BUILDING SCOPE ADDENDUM NO. 01

This Addendum is a summary of clarifications, interpretations, corrections and/or modifications to the Contract Documents for the Conestoga High School Athletic Fields Project prepared by Heckendorn Shiles Architects.

DRAWING NUMBER
A100

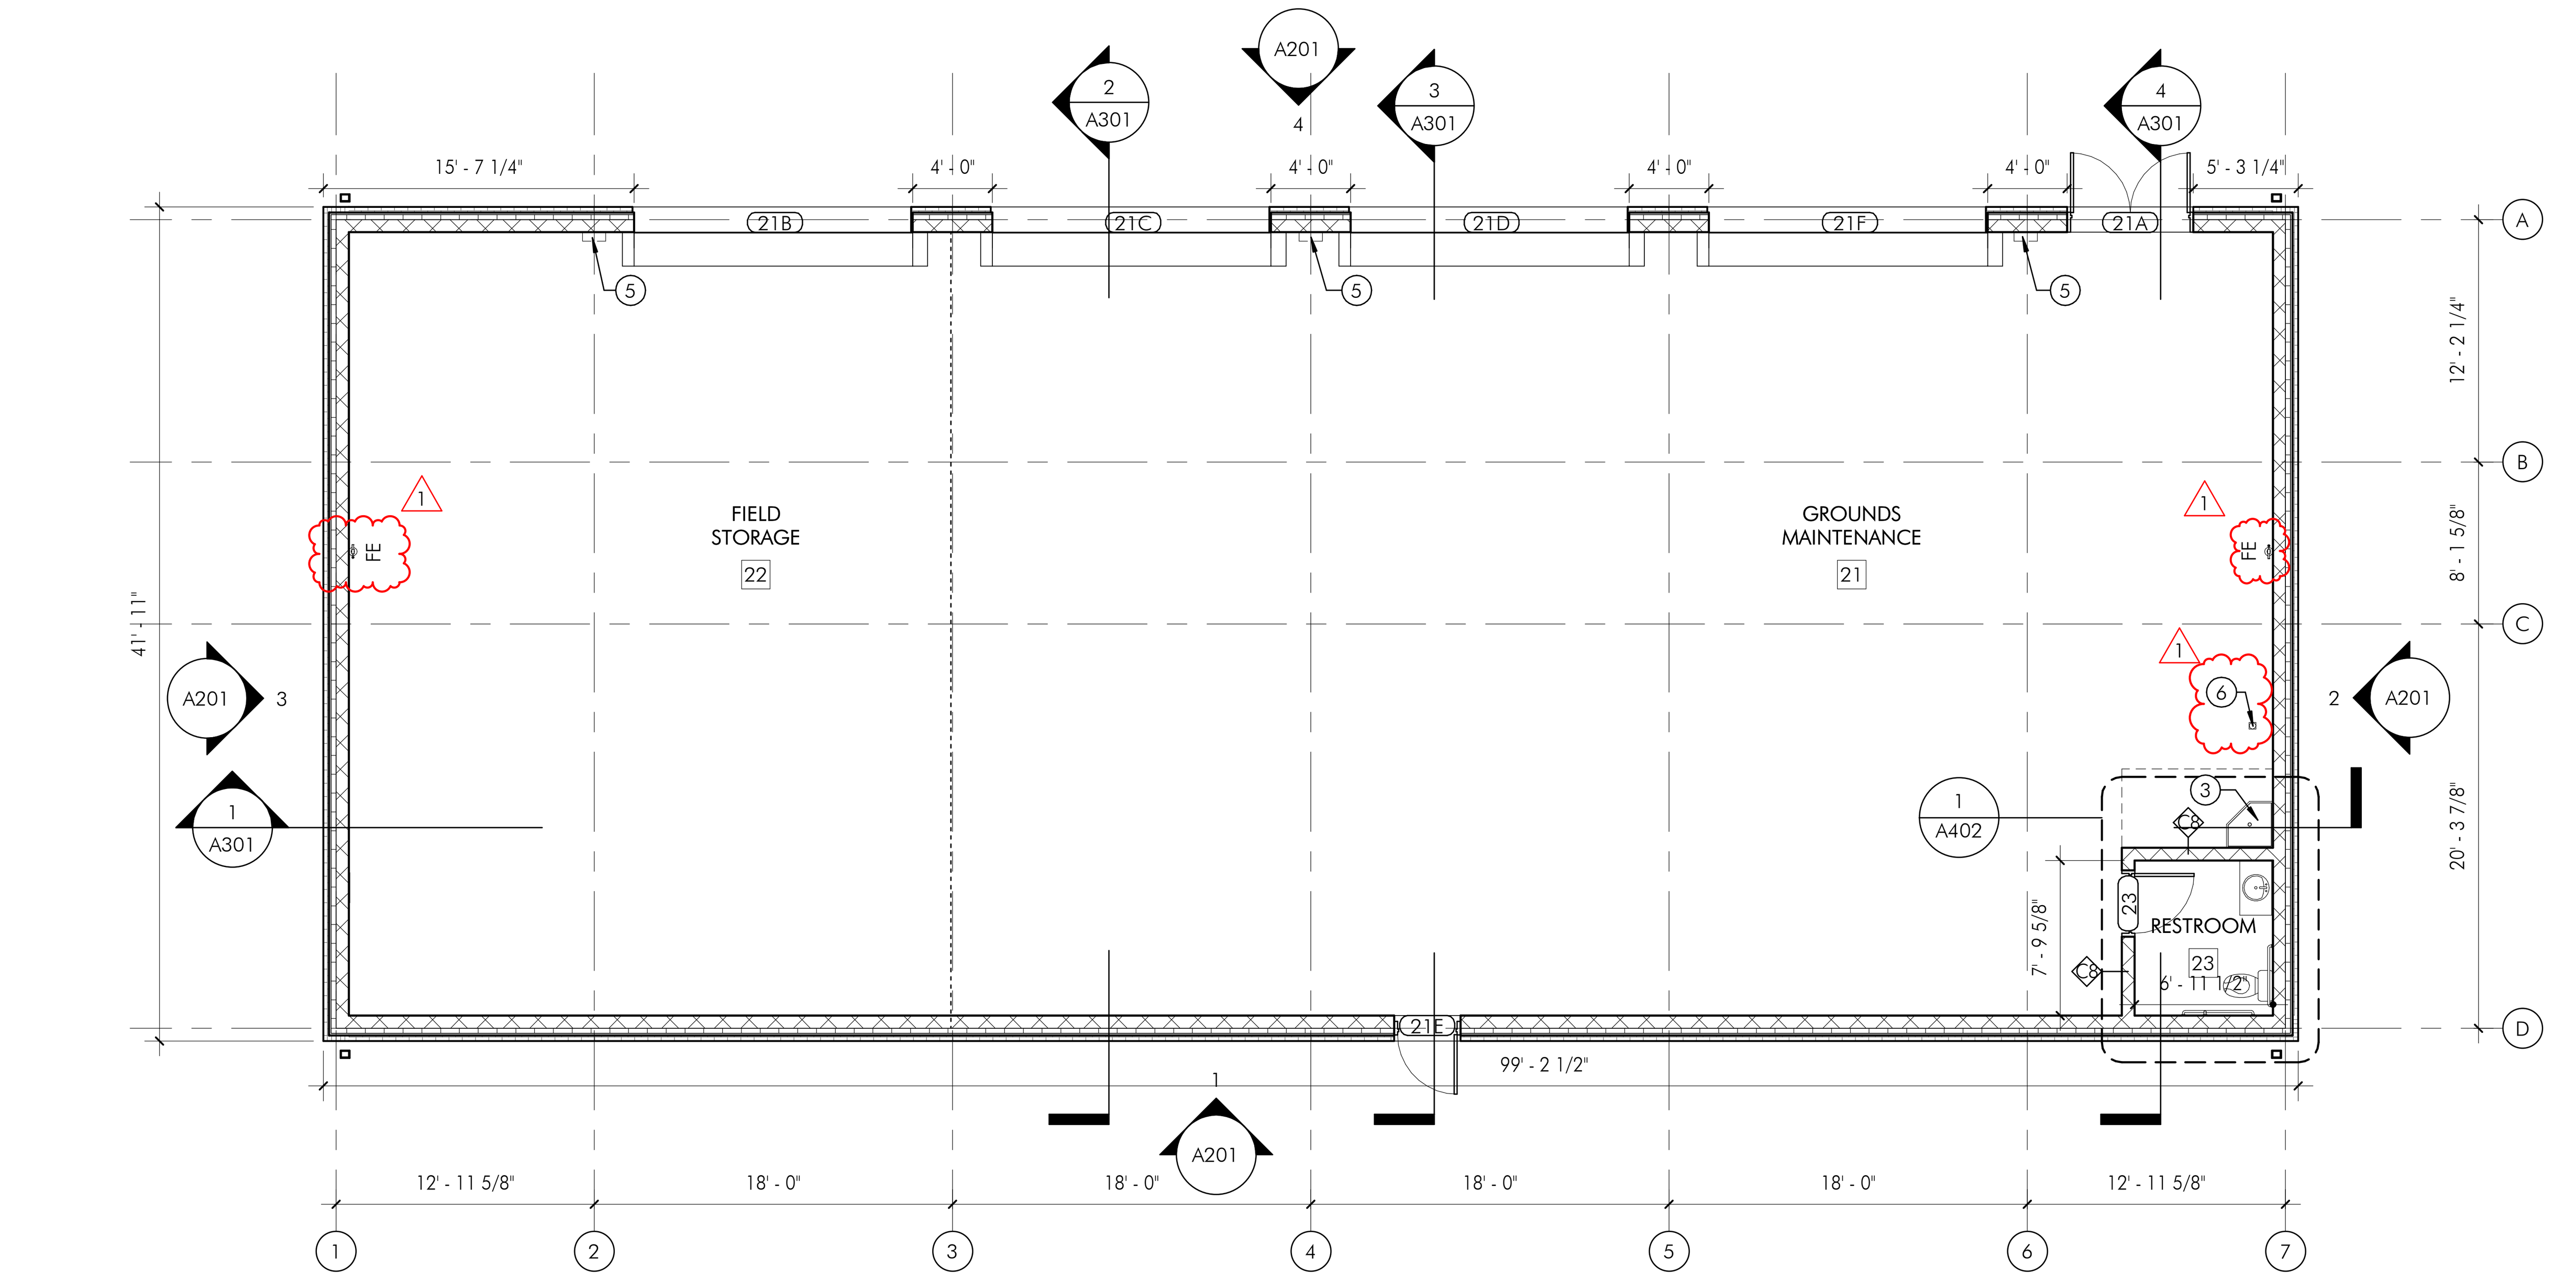
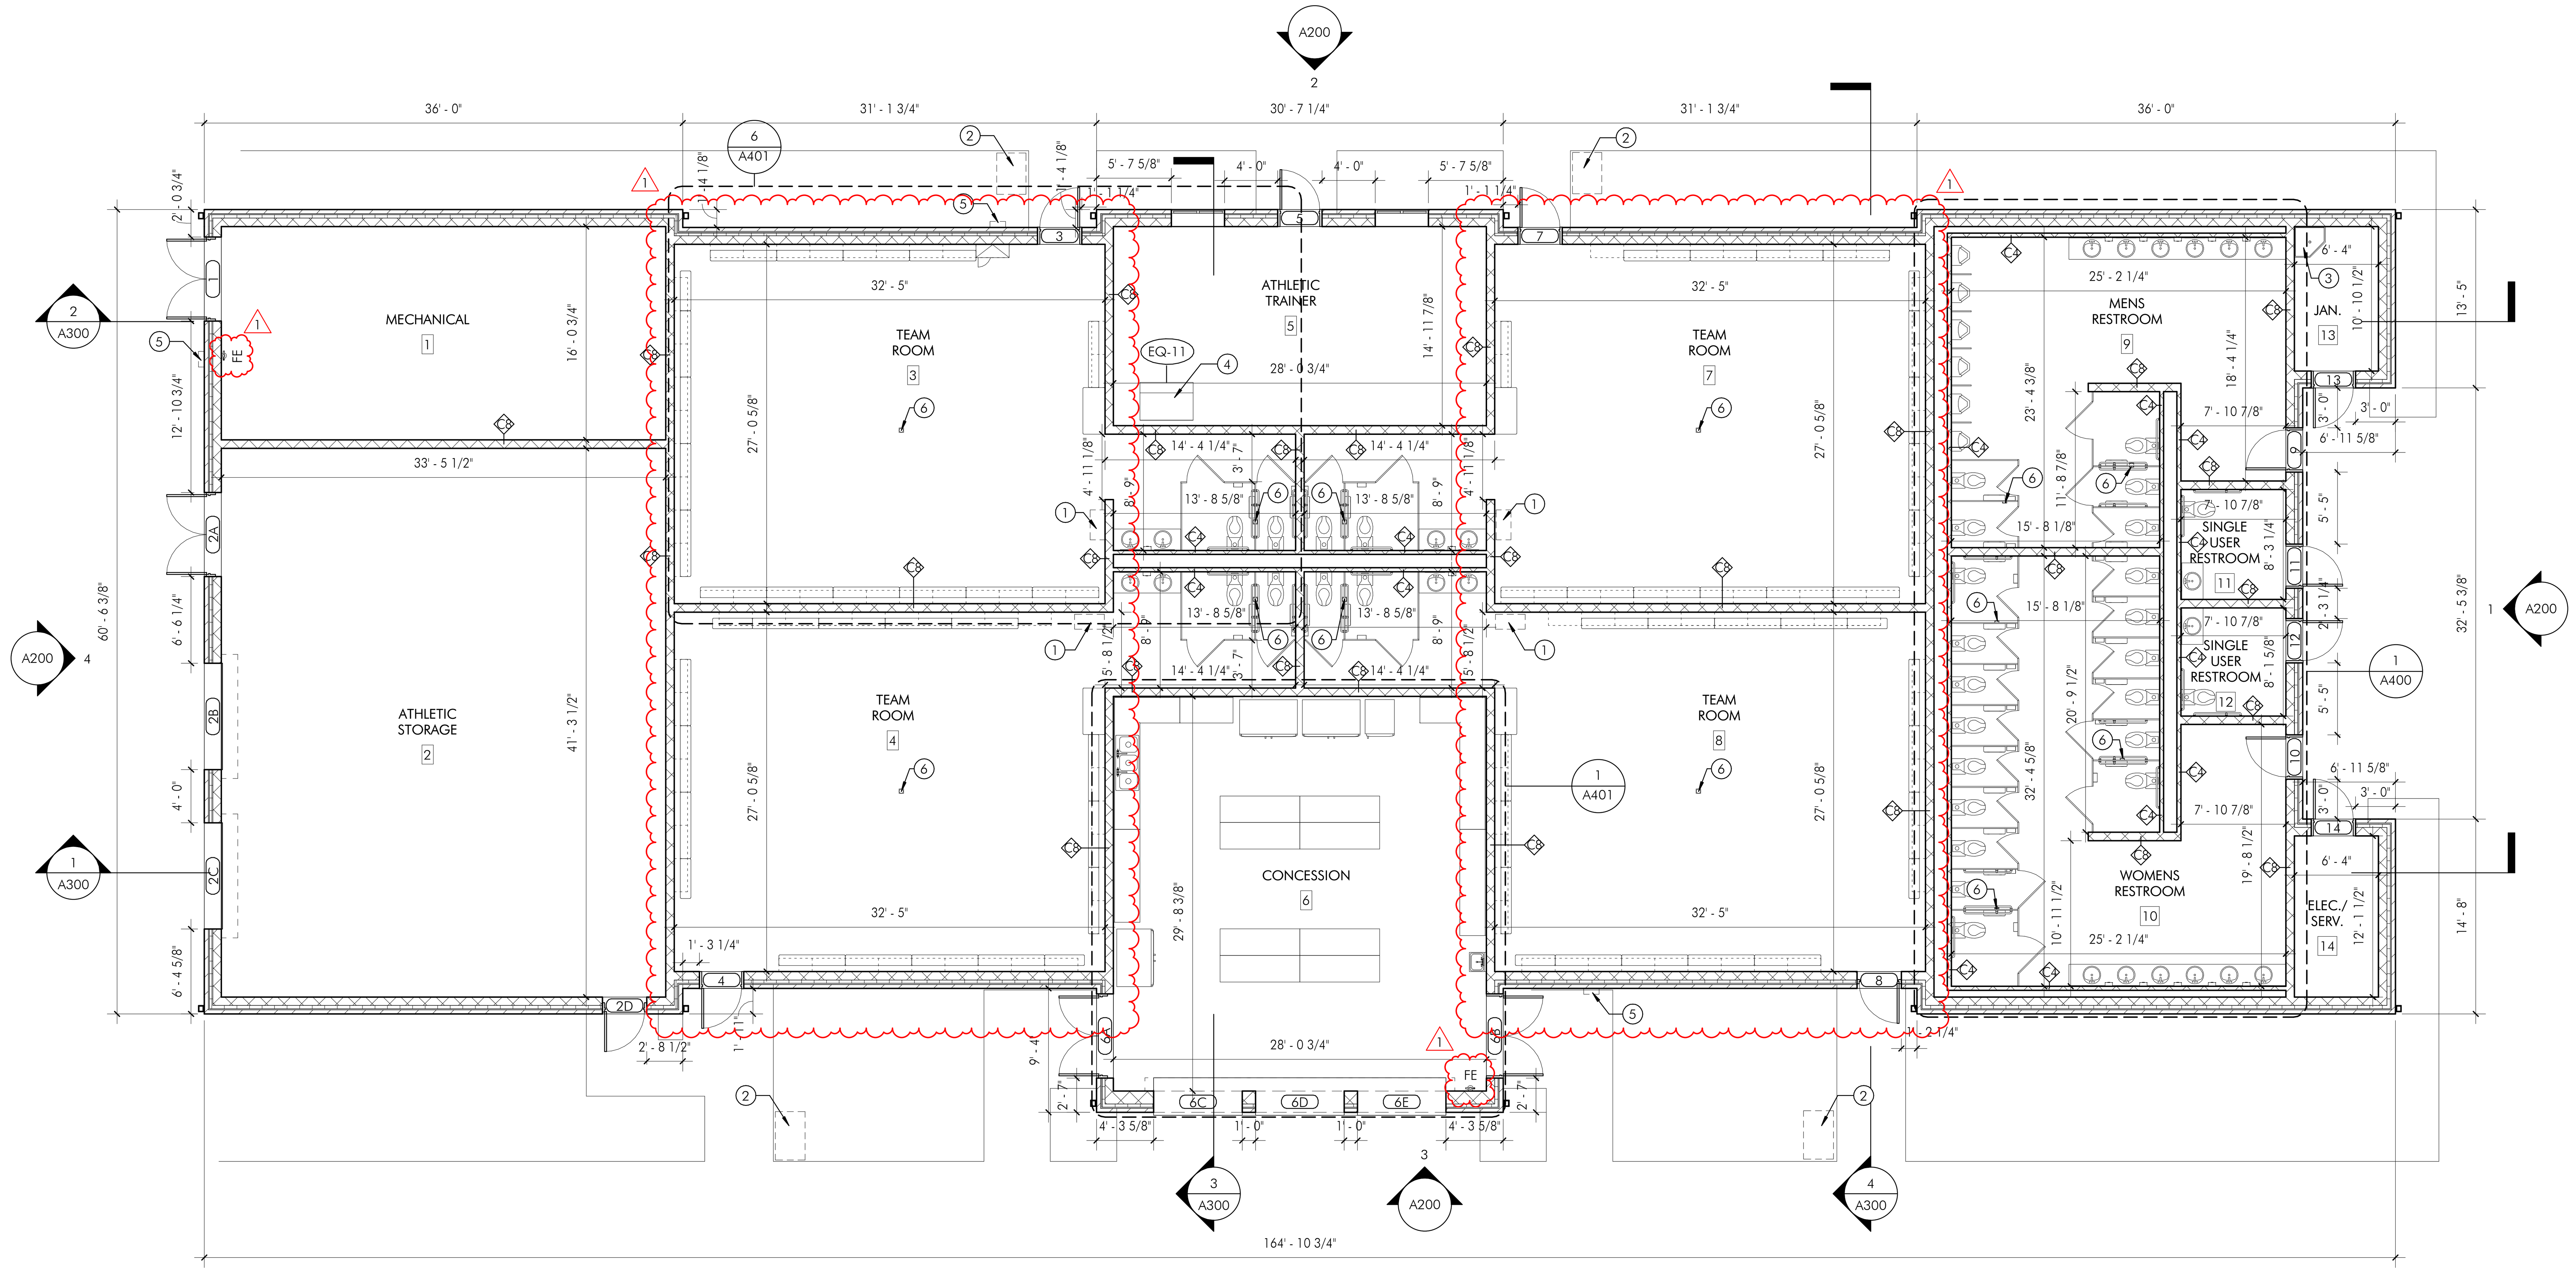
25. Question: Do we have installation locations and quantities for Fire extinguisher cabinets?
Response: Quantity and locations show on updated A100. They are mounted on brackets, no cabinets required.
